## CEQA BACKUP FOR JUNE 2021

- **Annexation No. 1094 to the Santa Clarita Valley Sanitation District of Los Angeles County, and Environmental Impact Report.**

PROJECT NAME: Master Case 14-077; Sand Canyon Plaza Mixed Use Project

1.	Introduction.....	1
1.1	Process .....	1
1.2	Content of the Final EIR .....	2
1.3	Review and Recommended Certification of the Final EIR.....	2
2.	Corrections and Additions .....	3
3.	Responses to Comments.....	5
3.1	State/Governmental Agencies .....	5
3.2	Public Comments .....	121
3.3	Public Comments During Planning Commission Meetings .....	159
4.	Project Revisions .....	185
4.1	Revisions to Project Description .....	185
4.2	Revised Project Description for Final EIR.....	189
5.	Project Design Features and Mitigation Monitoring and Reporting Program.....	201

**Figure 3-4 Tentative Tract Map 53074**

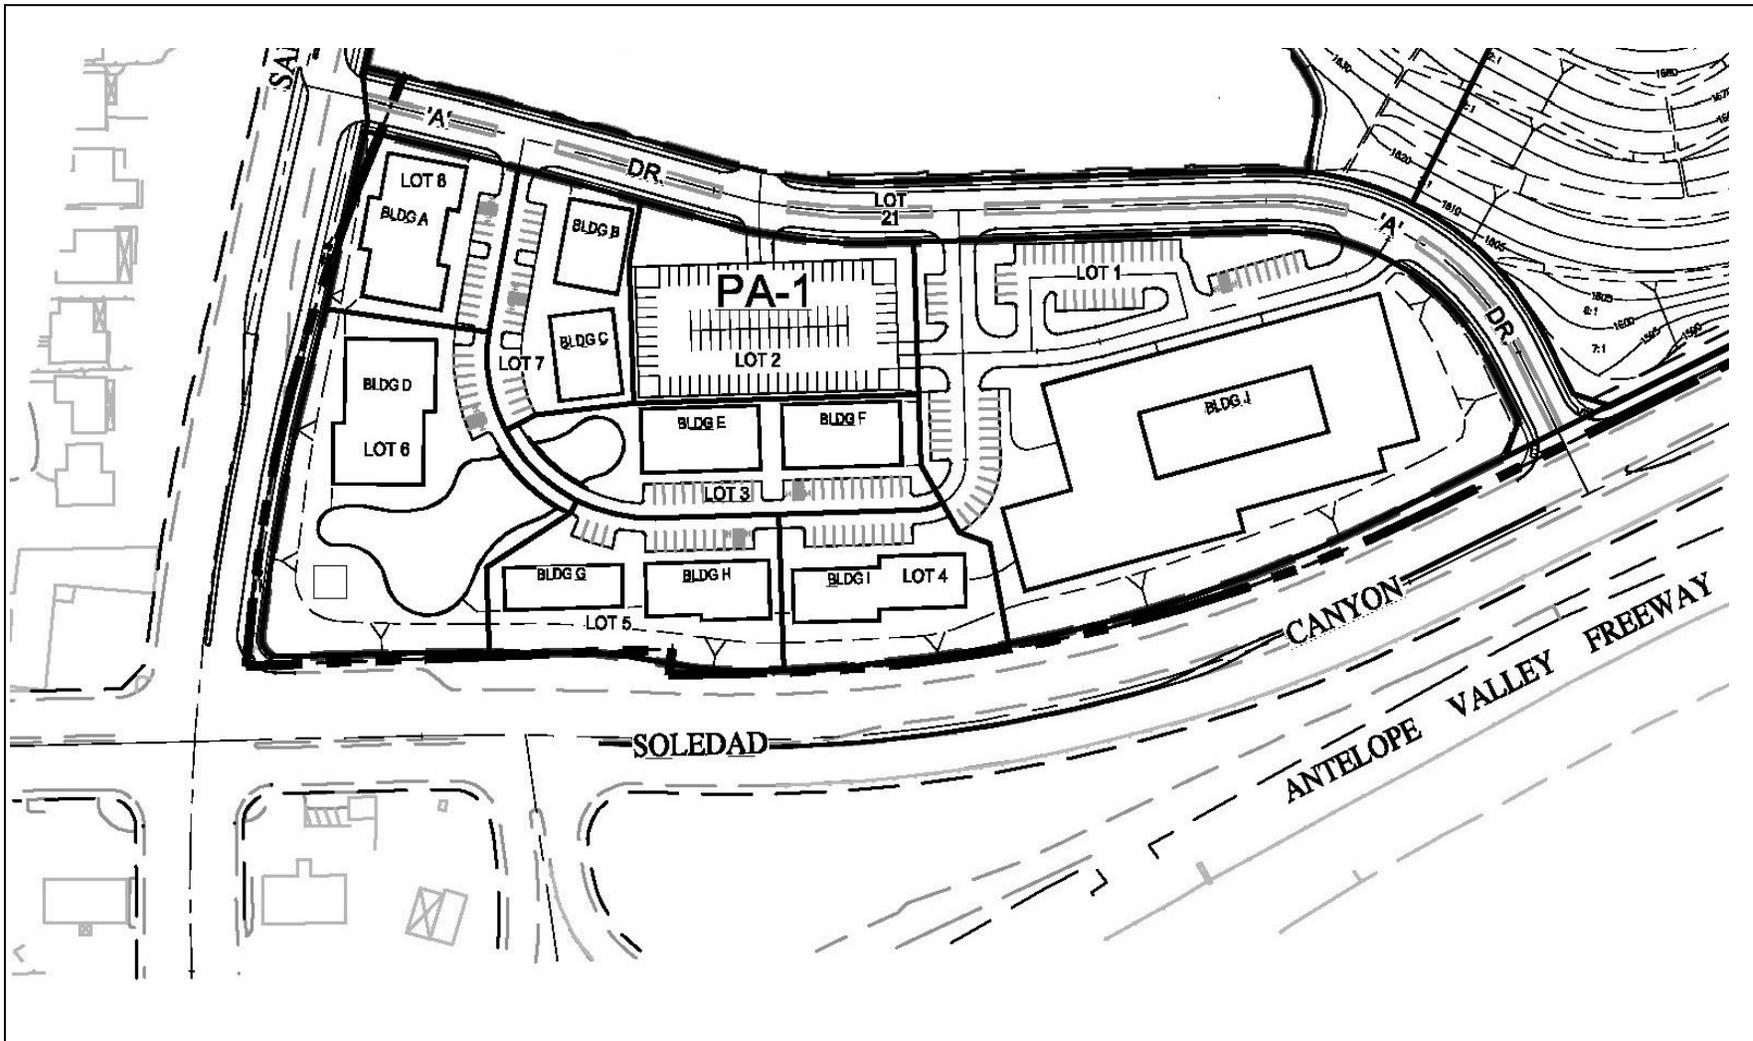
The Applicant has incorporated the revisions for Planning Areas 3 and 5 as shown on the revised site plan (refer to **Figure 3-4**).

The Applicant has incorporated the increase in commercial square footage for Planning Area 1 into the revised site plan (refer to the FEIR Figure 3-4).

**Figure 3-11 Planning Area 3**

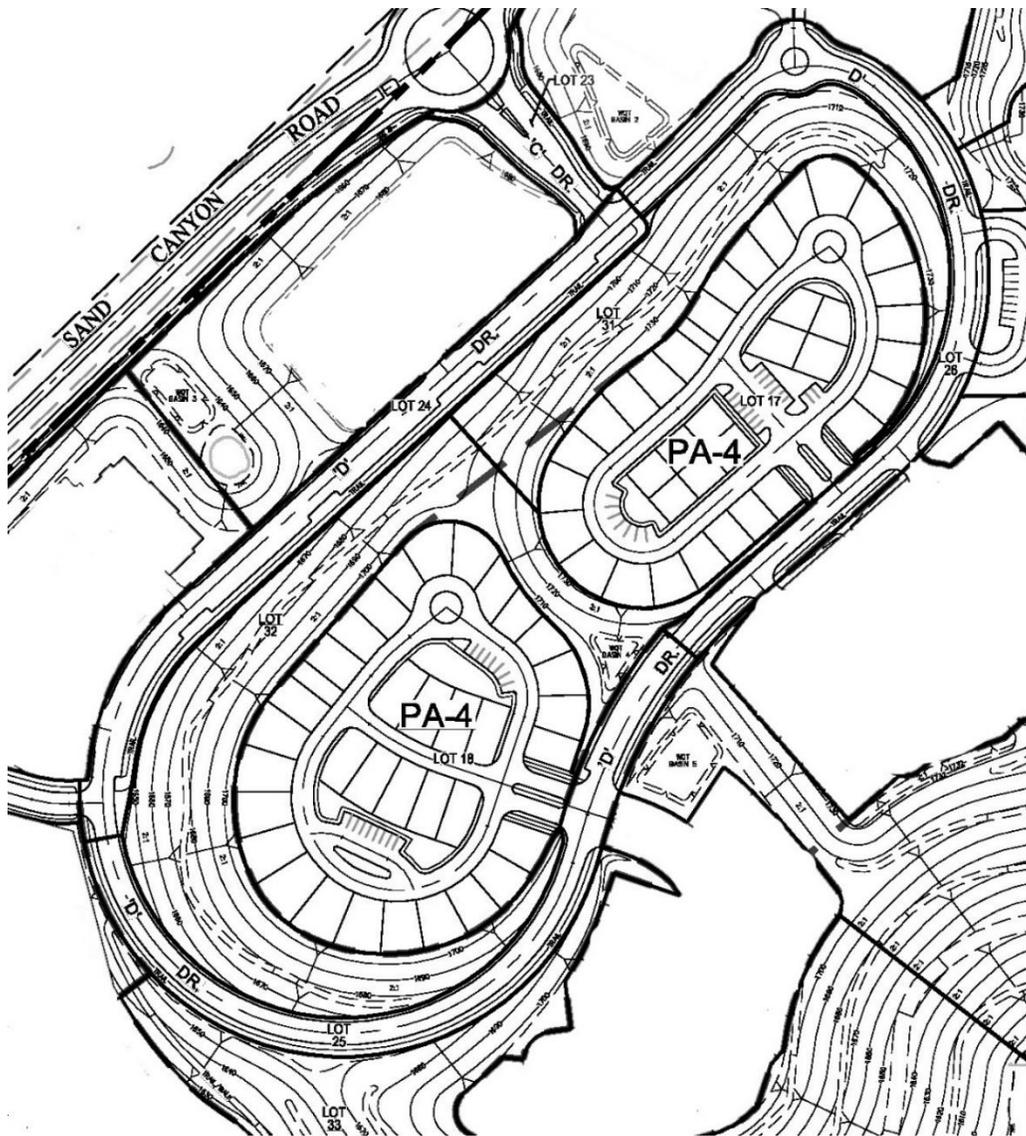
- Planning Area 3 (Multi-Family Attached Townhomes)** – ~~149~~122 townhomes with required parking (per the MXN ~~and UR-3~~ zone requirements) on approximately ~~10.3~~10.1 acres. ~~One private recreational area, w~~Water quality improvements, internal drive aisles, trails and other open areas would be provided within PA-3. The maximum building height in PA-3 is 40 feet. Access to PA-3 would be from Sand Canyon Road via “B”, “C” and “D” Drives. Planning Area 3 is located north of Planning Area 2 along Sand Canyon Road and is depicted in **Figure 3-11, Planning Area 3**~~Planning Area 3~~.

**Figure 3-13 Planning Area 5, Sheet 1**

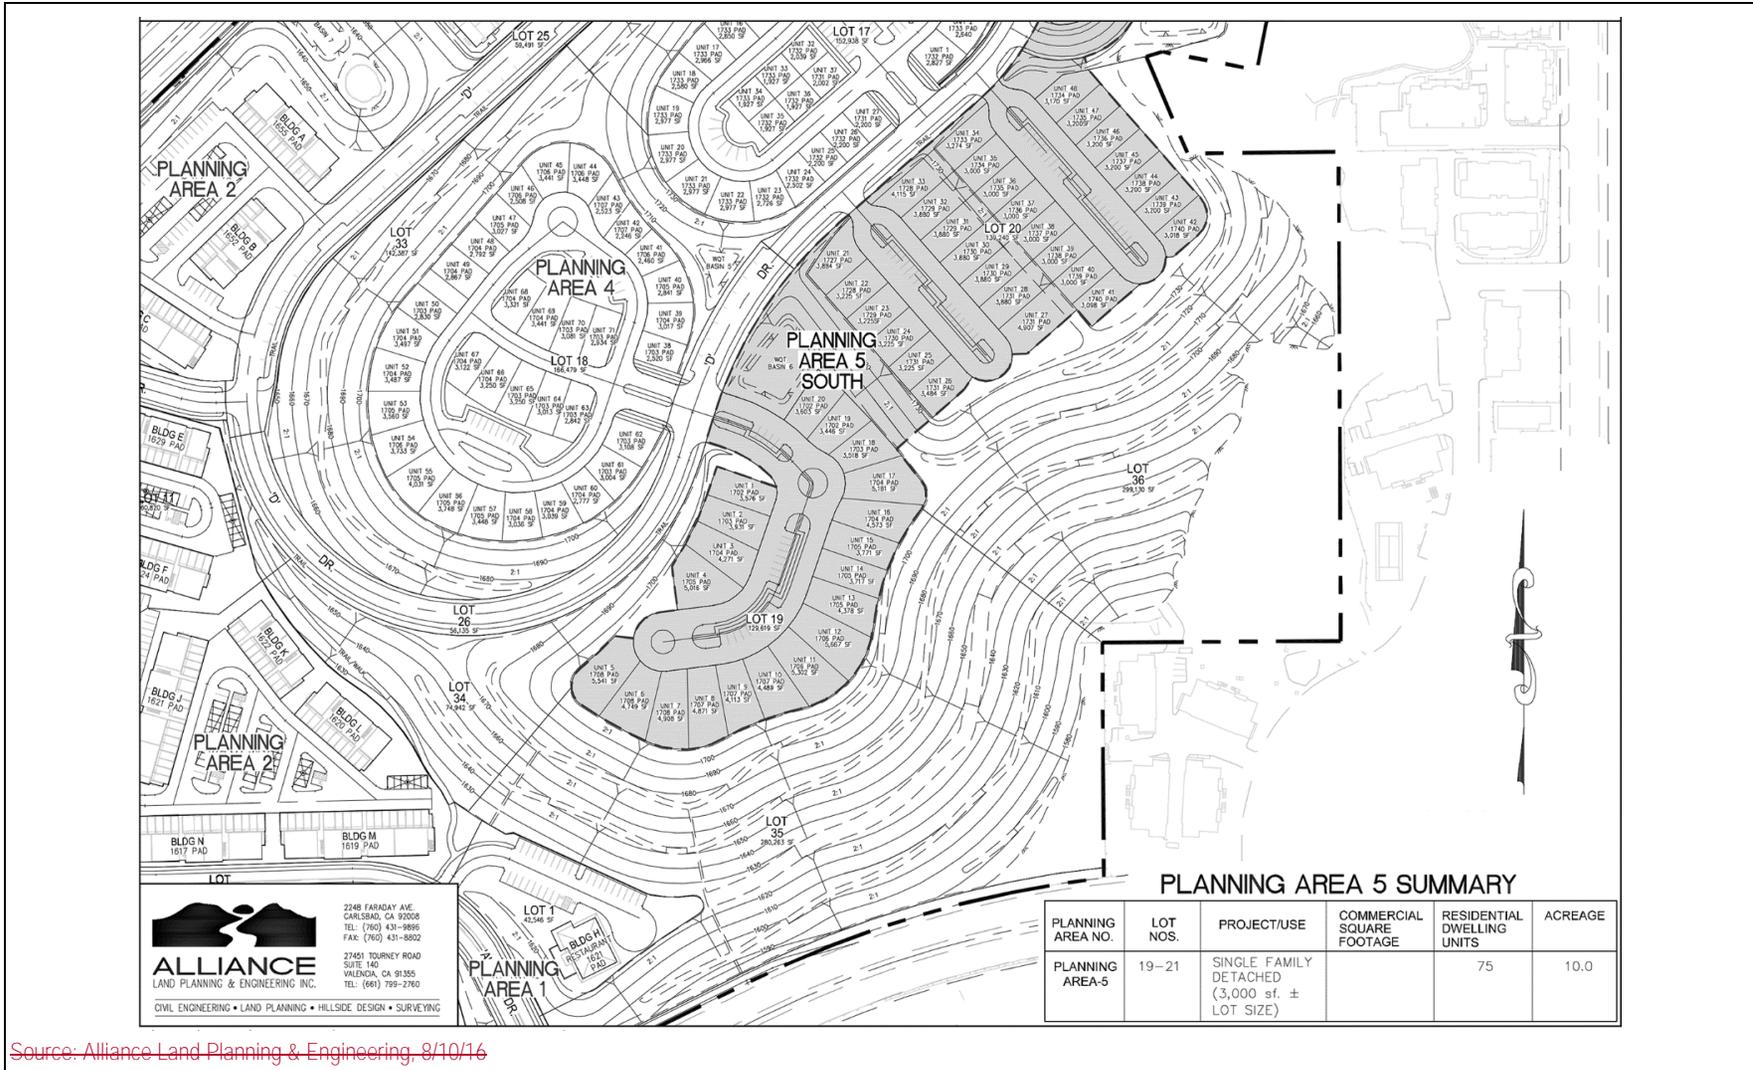
- Planning Area 5 (Single-Family Detached Condominiums~~Multi-Family Detached or Attached Condos~~)** – ~~48~~75 units with required parking (per MXN and UR-3 zone requirements) on approximately ~~6.3~~10.0 acres. ~~A 2.0-acre~~One private recreational area, internal drive aisles, water quality improvements, trails and other open areas would be provided within PA-5. Access to PA-5 would be from Sand Canyon Road via “B”, “C” and “D” Drives. Planning Area 5 is located in the eastern and northern portions of the Project site and is depicted in **Figure 3-13~~and~~ Figure 3-14**.

**Figure 3-16** ~~Figure 3-18~~ Soledad Canyon Road and Sand Canyon Road Cross-Sections

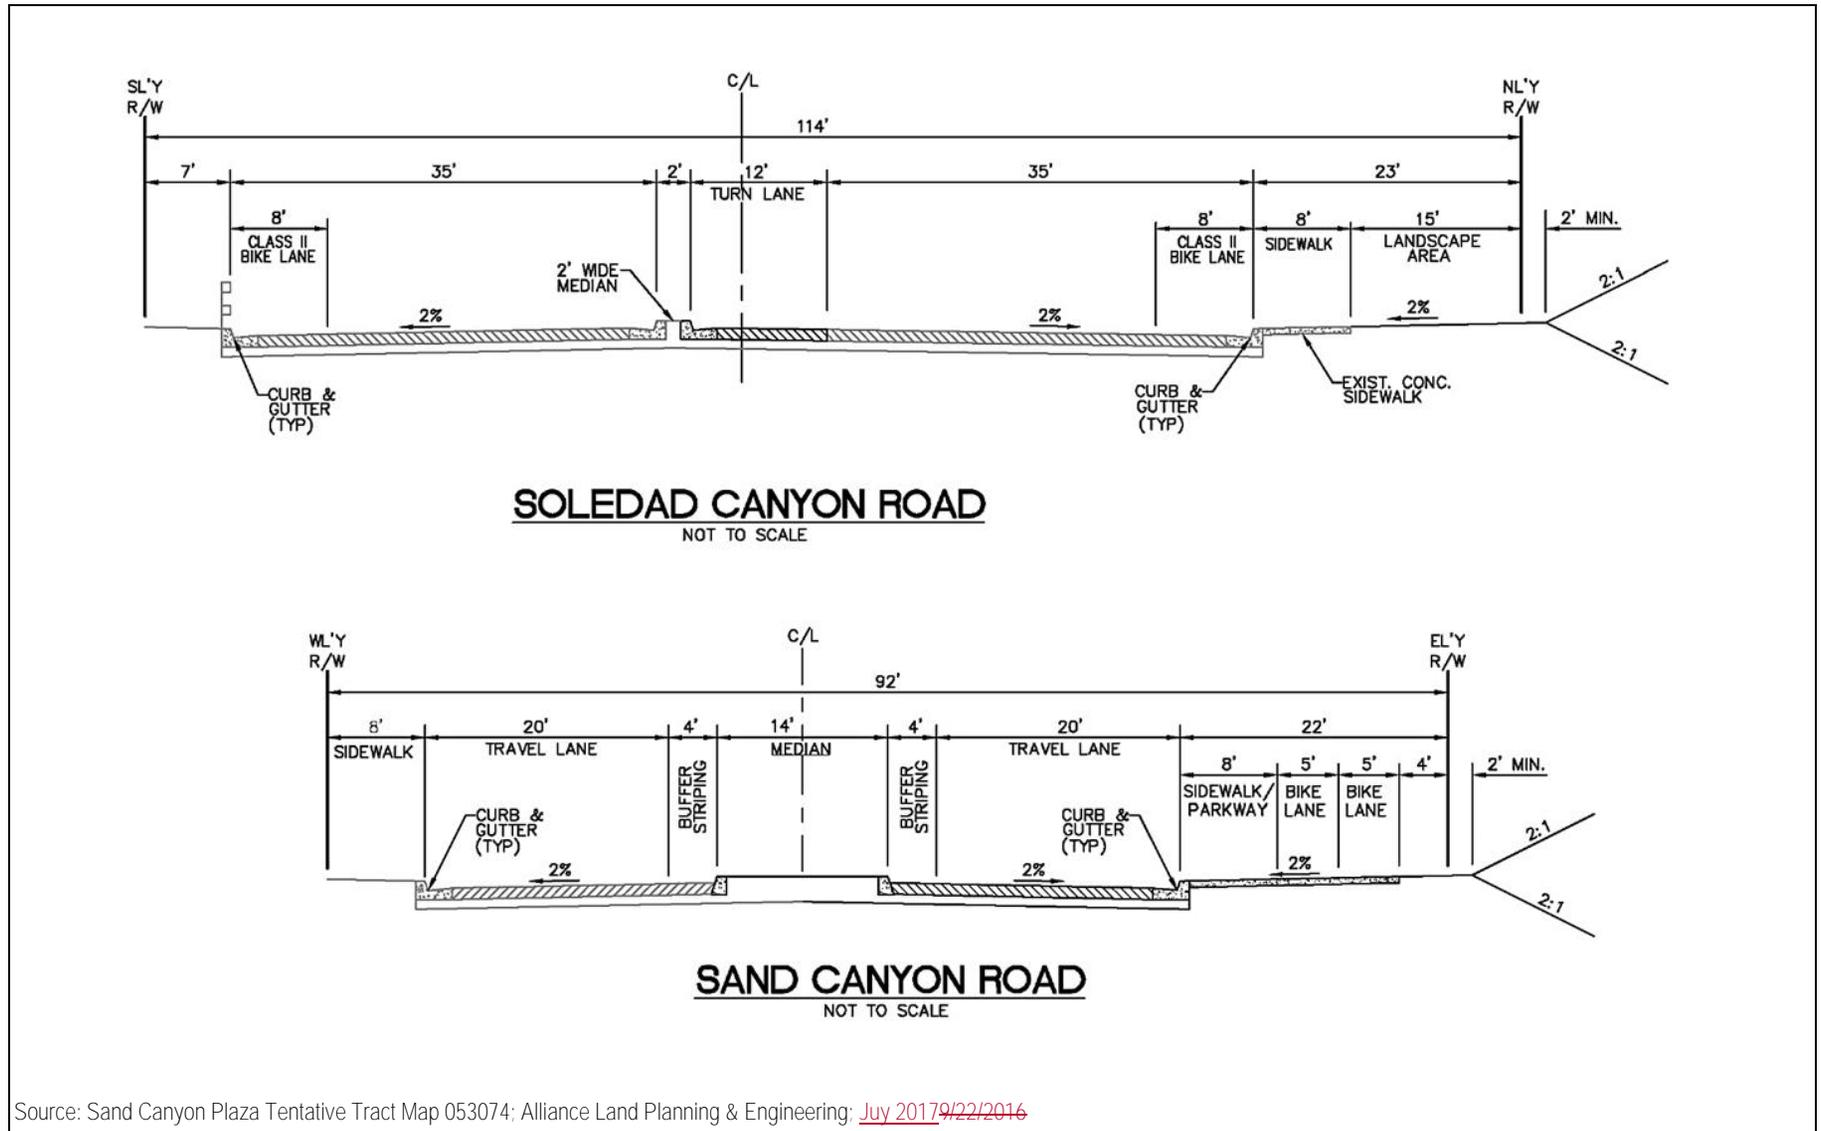
The interior of the Project would be served by private roadways. Private roadway right-of-way dimensions are provided in ~~Figure 3-19~~**Figure 3-18, Private Roadways Cross-Sections**~~Private Roadways Cross-Sections~~.
